Step-3 Report on
784 Memorial Drive

Includes a Calculation and Assessment of Queues,
as well as Traffic Mitigation Proposals and
Signal Warrant Study Results

prepared by Stephen H. Kaiser
191 Hamilton Street
Cambridge, Mass. 02139

February 25, 1999

FIGURE 6 SOLDIERS FIELD ROAD AND RIVER STREET BRIDGE

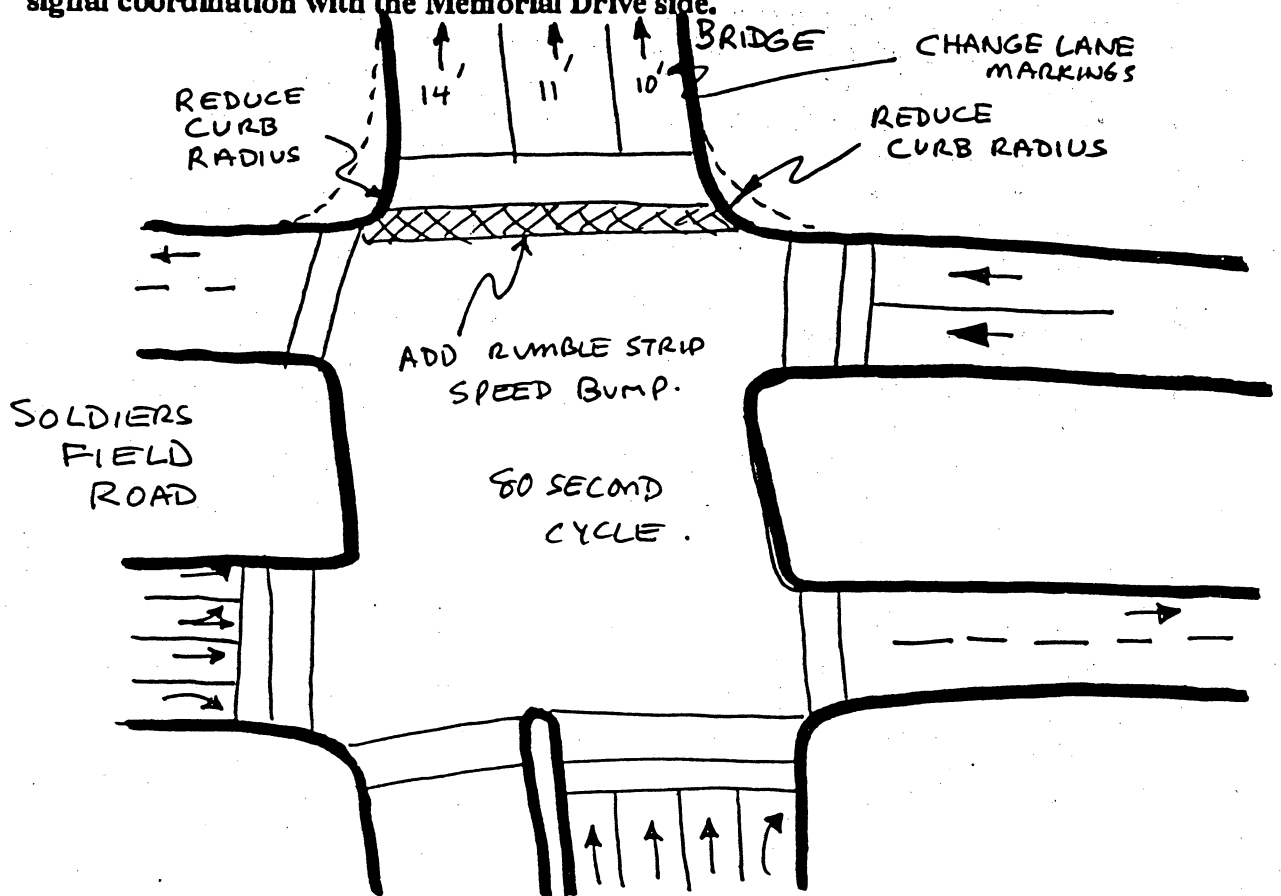
1. Traffic backs up from the Memorial Drive signal into the Soldiers Field Road intersection. Primarily the flows which are slowed or blocked are Cambridge Street and the Turnpike ramp.
2. The same traffic backup can slow or block the left turn from the service road onto the River Street bridge
3. Occasionally, some of the left turn traffic may get hung up in the intersection and may block the outbound exit ramp from Storrow Drive.
4. The Cambridge Street approach often will have long gaps as it approaches River street.
5. The four lanes on the approach in front of the hotel are more than the three lanes on the Turnpike exit ramp and on Cambridge Street. This is a short lane situation.

Generally, the right lane of the four approach lanes is for right turn traffic only and is not a critical lane. The challenge is to utilize the other three lanes more efficiently. Shorter signal cycles would reduce the queuing effects by about half, as would better signal coordination with the Memorial Drive side.

Traffic counts on the Cambridge Street approach show that the latter part of the signal cycle produces only 2/3 to 3/4 of the rate as the initial part, as queue backups begin to take their toll. For the overall phase, this effect is worth 10-12 seconds in lost time. Allowing for smoother flow into the left lane on the bridge may be worth an additional second or two at least. Another 2-3 seconds can be achieved from smoother startup of the inbound left turns onto River Street, without blocking queues.

However, the added startup lost time and all-red clearance time could amount to about 12 seconds, so the net time saved would be only about 3 seconds. At the moment, this added time may be best applied proving for added clearance time and allowing pedestrians to have a jump on traffic during the only time that pedestrians using the Esplanade path can cross – during the phase for the outbound off-ramp from Storrow. It may be desirable to install a concurrent signal at this location, with WALK indications, and signs saying yield to pedestrians on turns. Vehicles today tend to yield when turning, and such a crossing would be an improvement over the incredible Dodge City nature to today's crossing location. Without a doubt, this crossing represents the worst and most dangerous crossing on the entire bikepath on the Boston side of the River (even worse than Leverett Circle!)
